REQUEST FOR QUOTATIONS
W.G. Johnson Storage - Lunch Room Renovation
RFQ#: Q24-98
ADDENDUM #3

The following questions and answers are hereby issued in response to the questions of prospective respondents. **Please note that certain information is removed from the respondents' questions in order to protect the respondent's identity.**

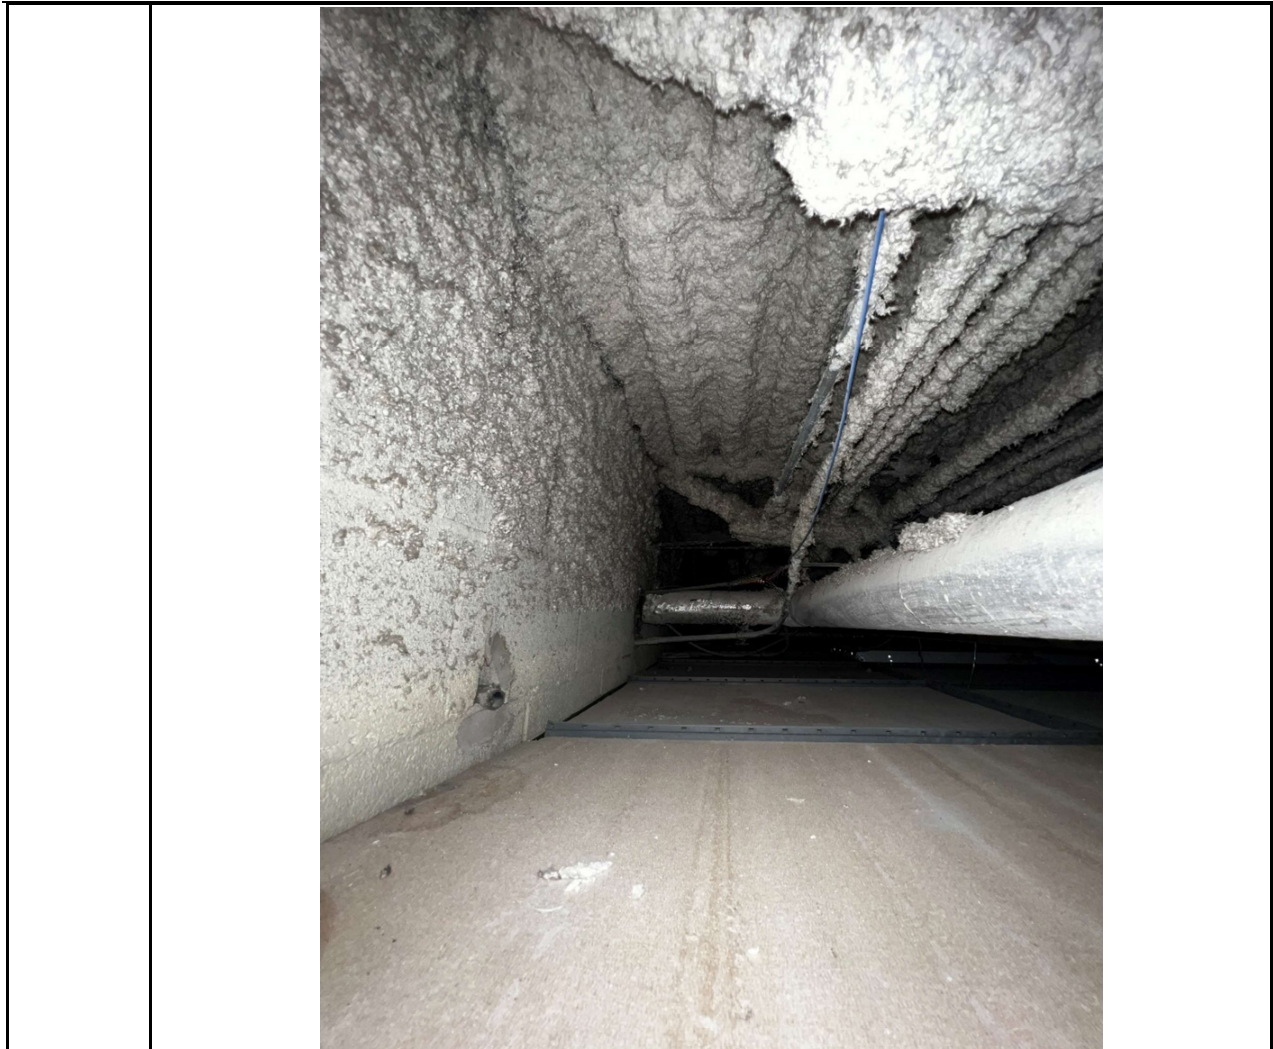
Question #2	Can you kindly confirm/advise if the existing folding door track is to be removed?
Answer #2	Refer to Answer #1
Question #3	Does note #20 which is listed under " <i>specific demolition notes</i> " mean that the existing W10 beam is to be removed? As per our review during site visit, this beam is not in the way of the new CMU block infill as it is located off the existing CMU block wall. Please advise and confirm.

Answer #3	Demo Note 20 refers to the potential existence of a W10 beam attached to the existing joists - directly above the existing roll up door to support the folding partition. If there is a

W10 beam directly above the exiting roll up door, its removal would then need to be coordinated with the Architect and Structural Engineer to accommodate new masonry block wall fill below. See snippets of existing drawings below for reference.

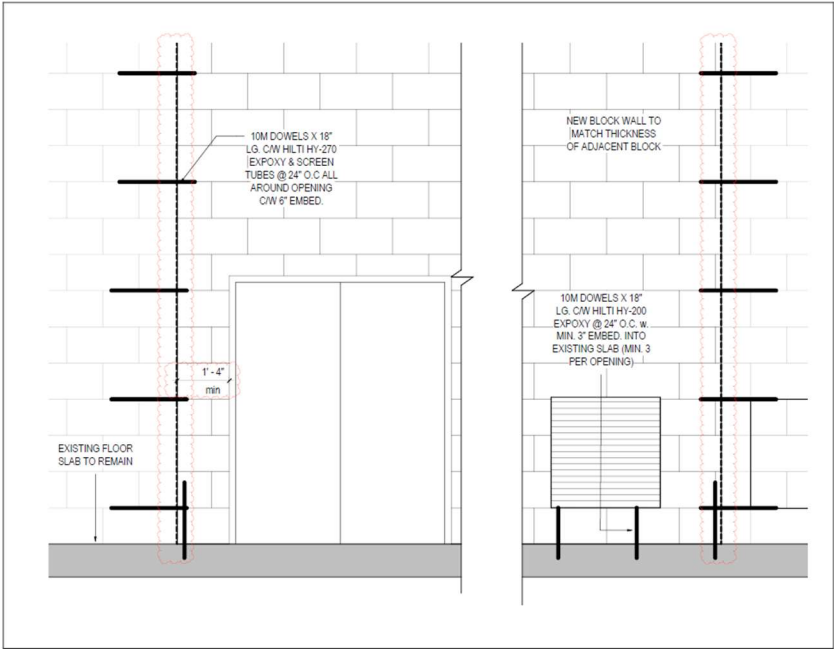
Question #10	Can you advise what is the area located above the existing corridor R129? Is this location accessible to build-up the new specified W-5? What is the wall W-5 finish at this area? Can you kindly provide photos of this area to review and see if any existing finish will be affected by the removal of the existing CMU block wall? Is it possible to provide a section at this area and specify the requested information on it?

Answer #10	Please see photos below. Refer to answer #29 for further details on this area.

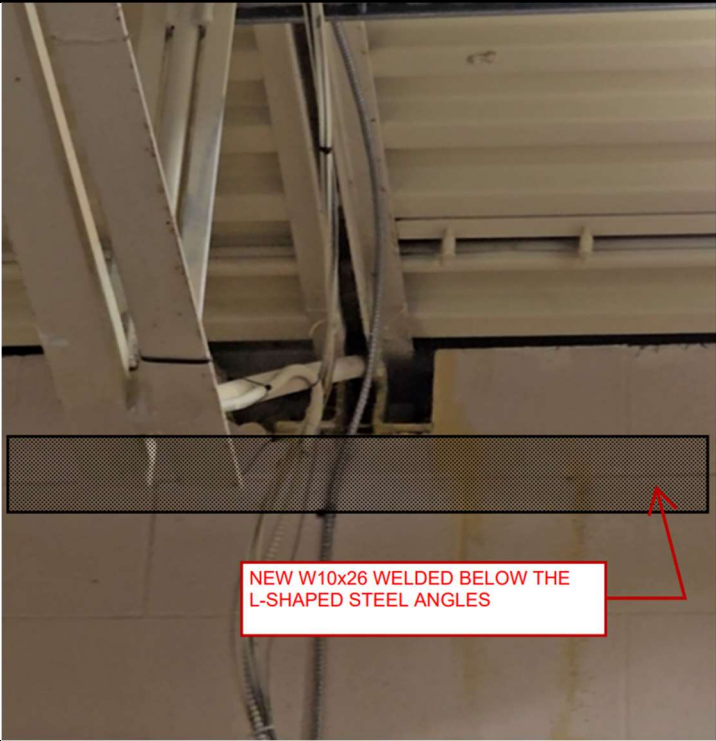
Answer #13	Not for the renovated area
Question #14	May the city kindly consider an extension to the closing deadline?
Answer #14	No
Question #15	Are the existing blocks imperial or metric? Imperial blocks are not available, and this would make it difficult to tooth block in to existing.
Answer #15	<p>Please see below for updated infill detail. Replace toothed in detail with straight cut with ties as per notes below.</p>  <p>5 TYPICAL BLOCK WALL INFILL SCALE: 1/2" = 1'-0"</p>
Question #16	Are the ends of the existing walls that are to be toothed filled solid?
Answer #16	Unknown. Please refer to Answer #15
Question #17	Would it be possible to not tooth the existing and new block wall together and instead tie the new wall into the existing wall with a strap tie?

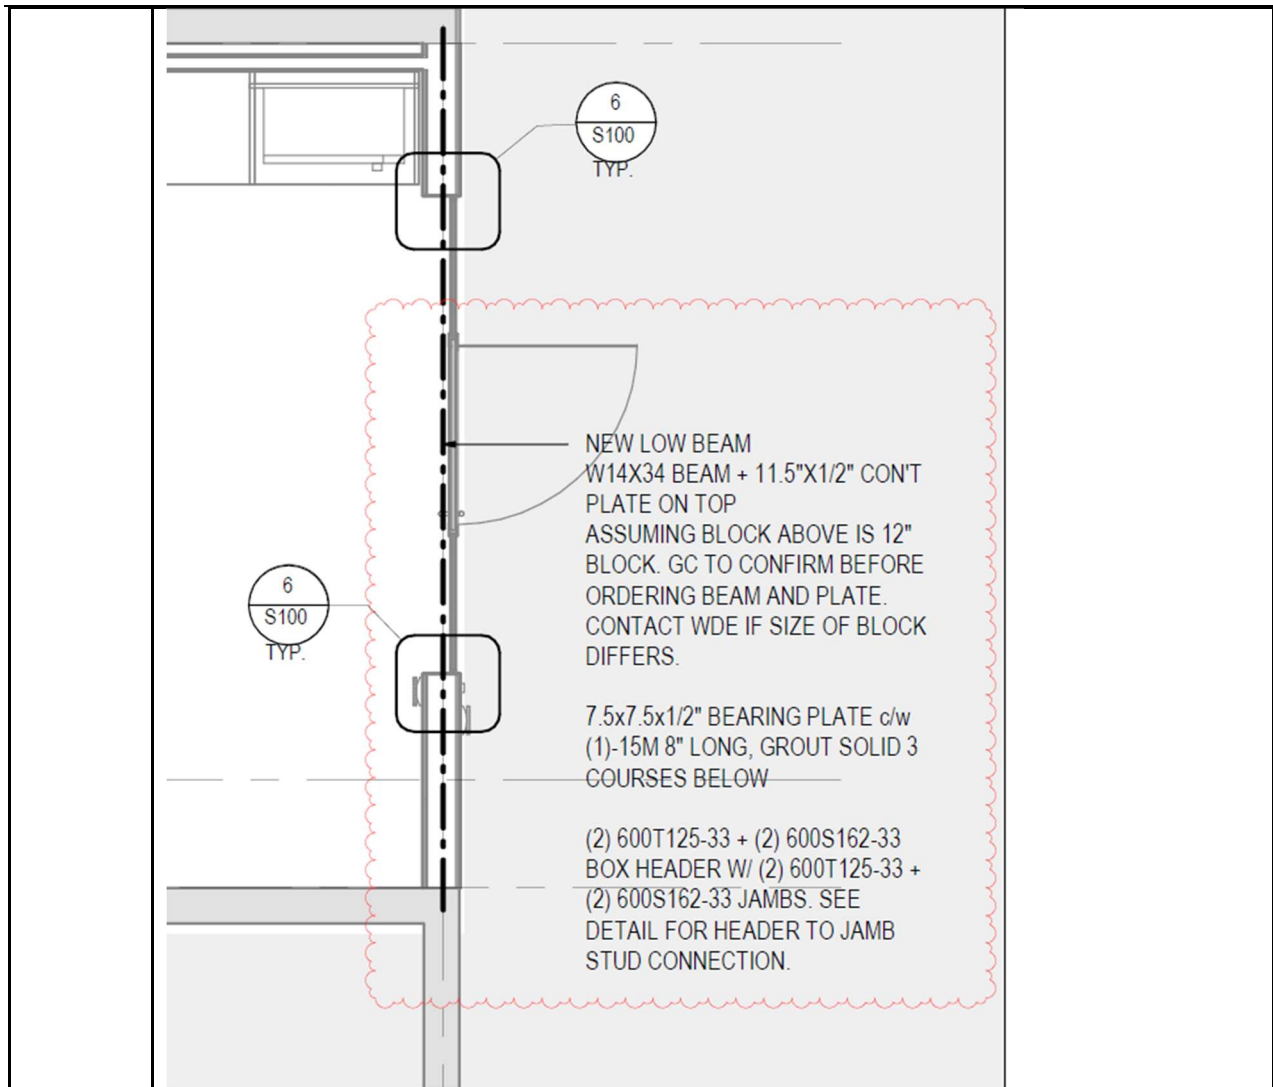
Question #23	Can you specify the size of the masonry units?
Answer #23	Please refer to Answer #15
Question #24	Does the new opening for relocation of grille require a lintel?

Answer #24	<p>Yes, this new opening will require a lintel. Please see below for lintel size of door and new opening for relocation of grille:</p> 
Question #25	Note 6 in A200 reads "Provide interior glazing wall system in aluminum frame with integrated glass swing door". Door schedule suggest that is an existing door to be relocated. Please advise

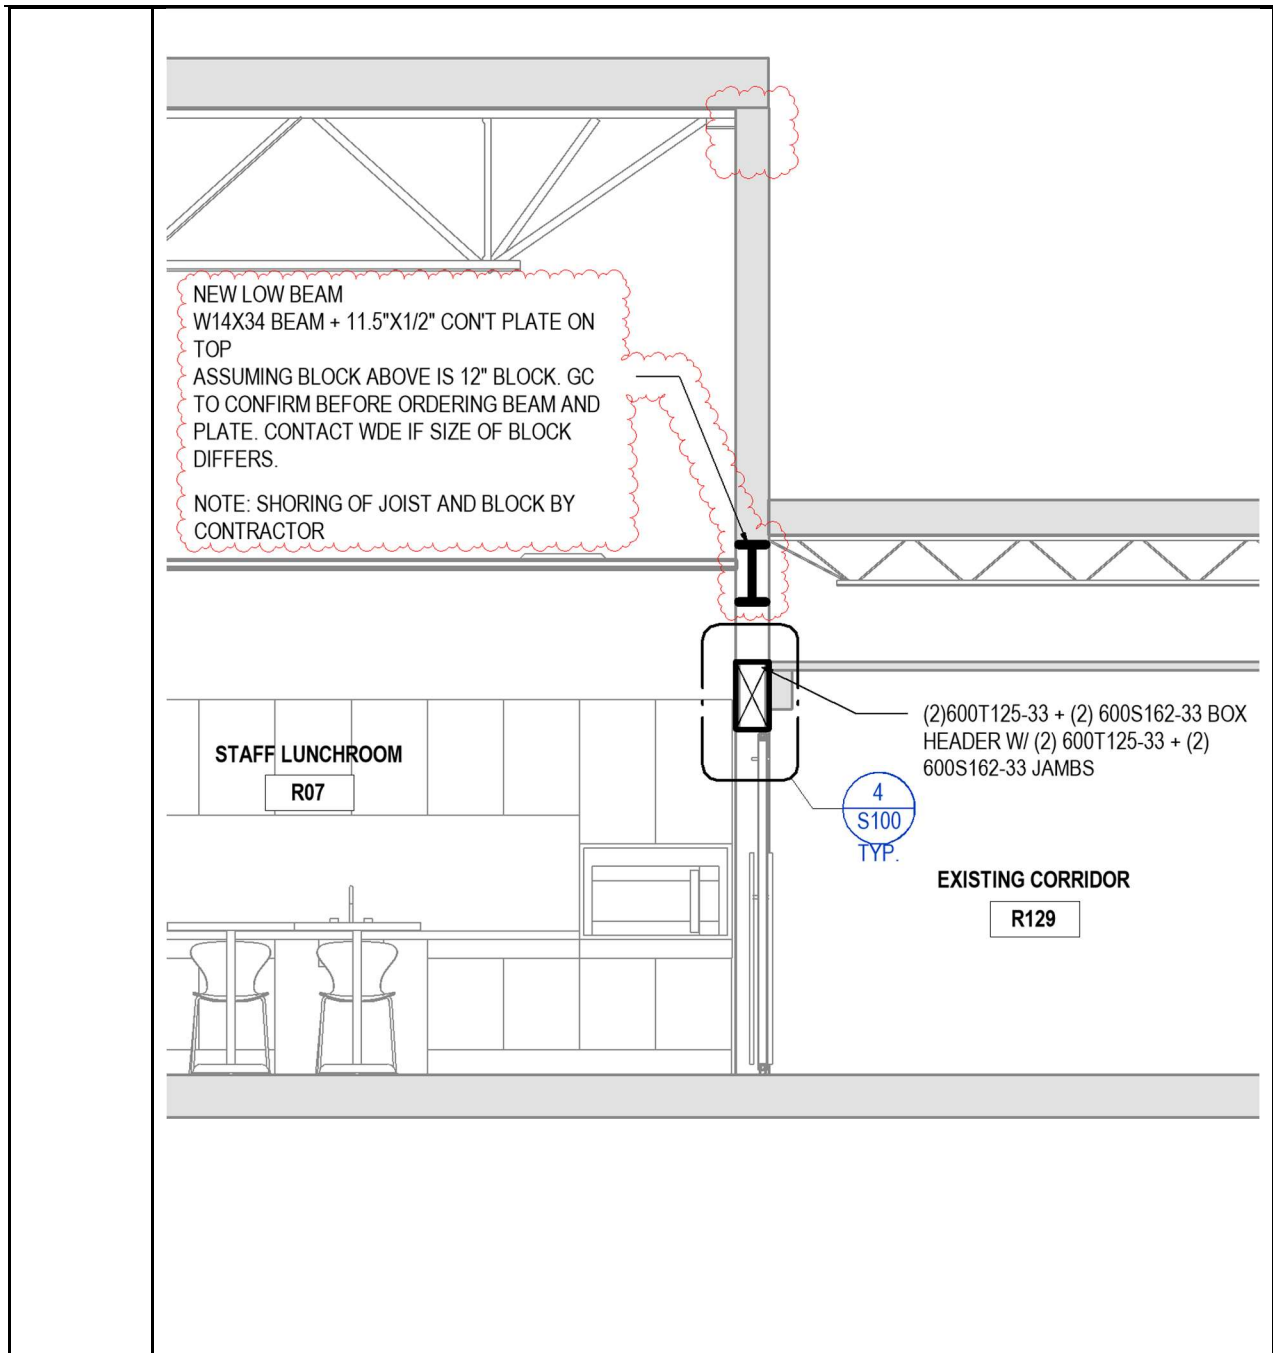
Question #29	Referring to the below photo, would you kindly confirm the location of the new added steel beam W10x26 (to replace the removed load bearing block wall).
